**STATE OF NEW HAMPSHIRE
INTER-DEPARTMENT COMMUNICATION**

FROM:  Andrew O'Sullivan Wetlands Program Manager	DATE: February 21, 2020
SUBJECT: Dredge & Fill Application Loudon-Canterbury, 29613A Response to RFMI (DES#2019-03745)	AT (OFFICE): Department of Transportation Bureau of Environment
TO: Kristin Duclos, Wetlands Specialist	
THRU: Karl Benedict, Public Works Permitting Officer New Hampshire Wetlands Bureau 29 Hazen Drive, P.O. Box 95 Concord, NH 03302-0095

STATE OF NEW HAMPSHIRE
DEPARTMENT OF TRANSPORTATION
WETLANDS PLANS
FEDERAL AID PROJECT

X-A004(458)
N.H. PROJECT NO. 29613A
NH ROUTE 106

EROSION CONTROL PLAN LEGEND	
	PERIMETER CONTROL
	NATURAL BUFFER/PERIMETER CONTROL
	CHANNEL PROTECTION
	CLEAN WATER BYPASS

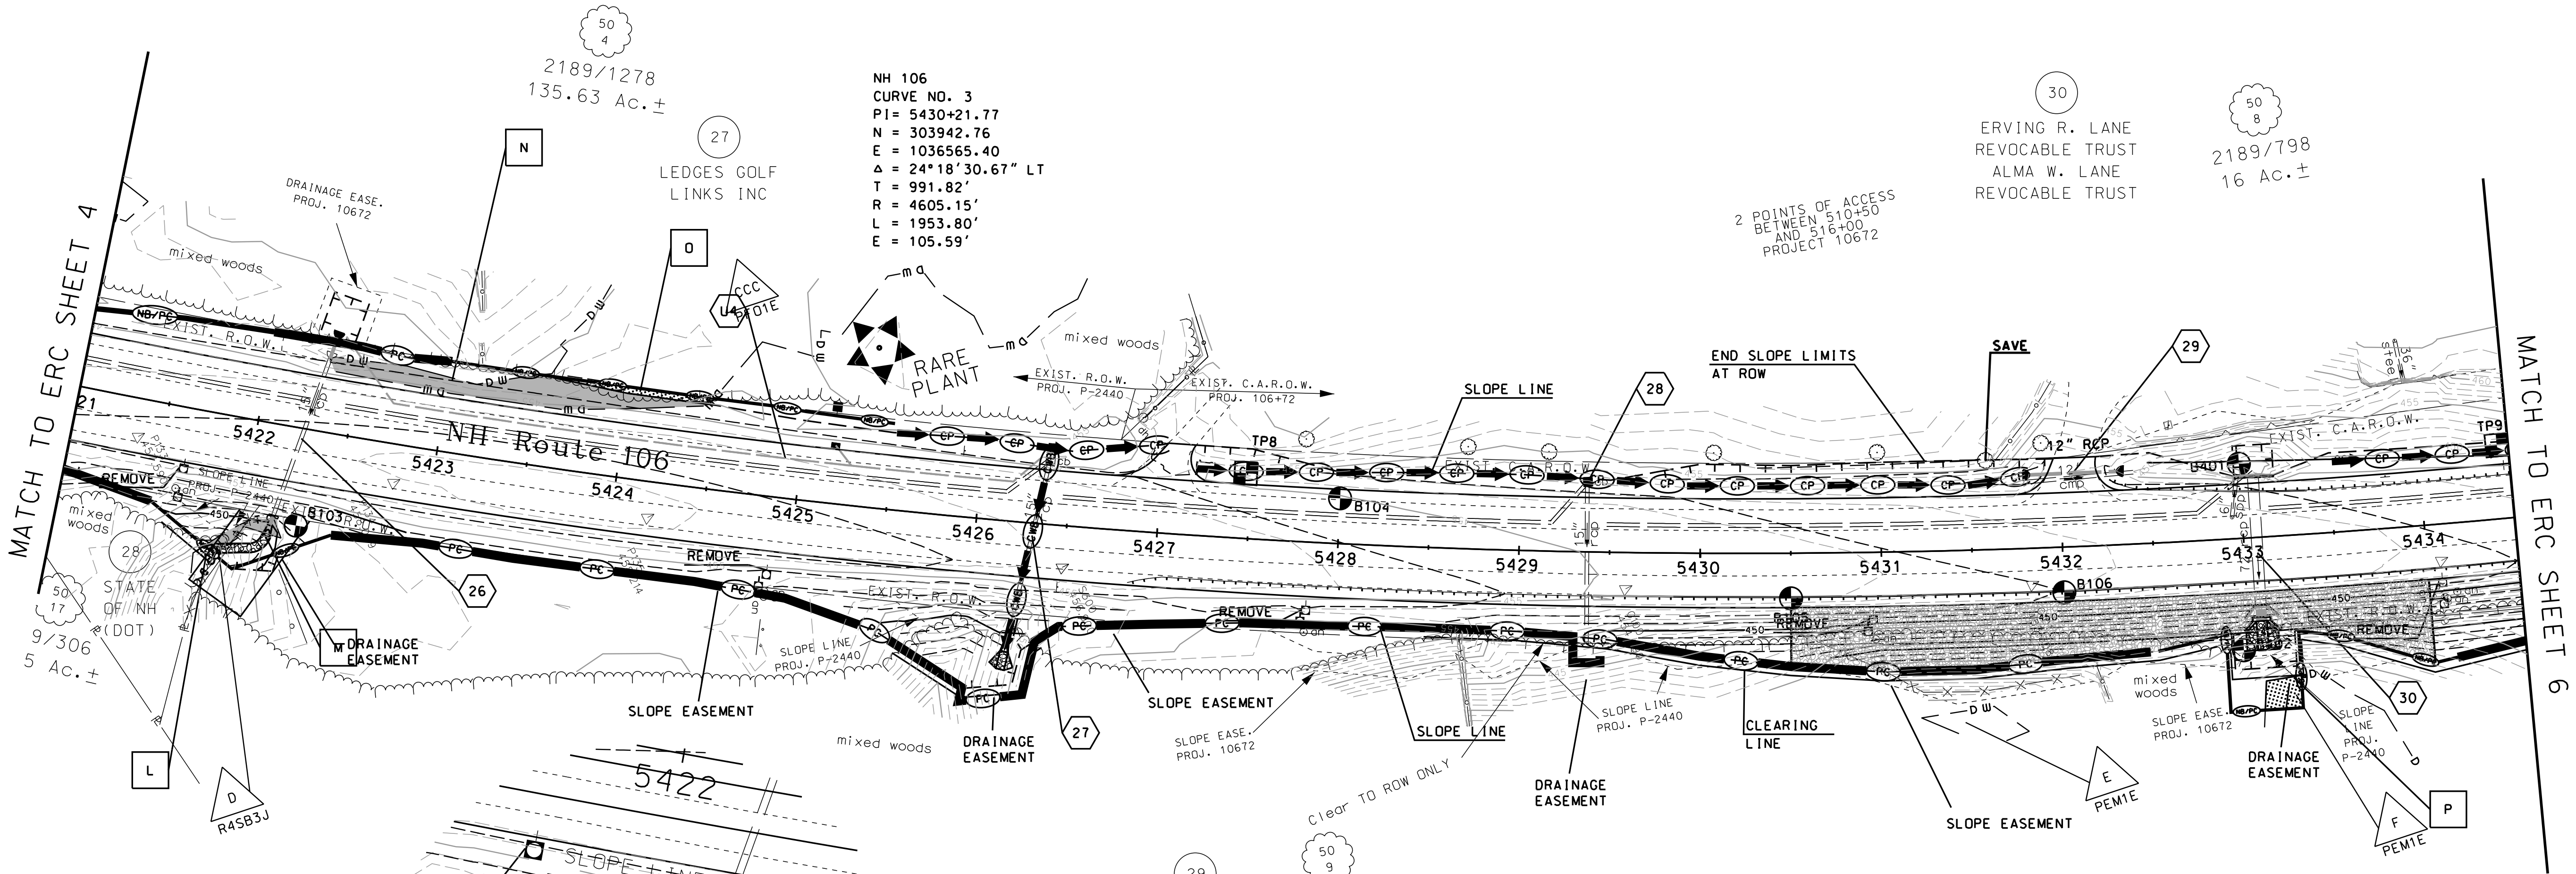
22. Pursuant to Rule Env-Wt 501.02(a)(2)q., please revise the Erosion Control Plans to include the appropriate erosion and sedimentation controls around wetland impact areas "K" and "R."

22. Erosion Control Plans now show a combination of perimeter control and channel protection for the revised impact areas "K" and "K2", as well as impact area "R".
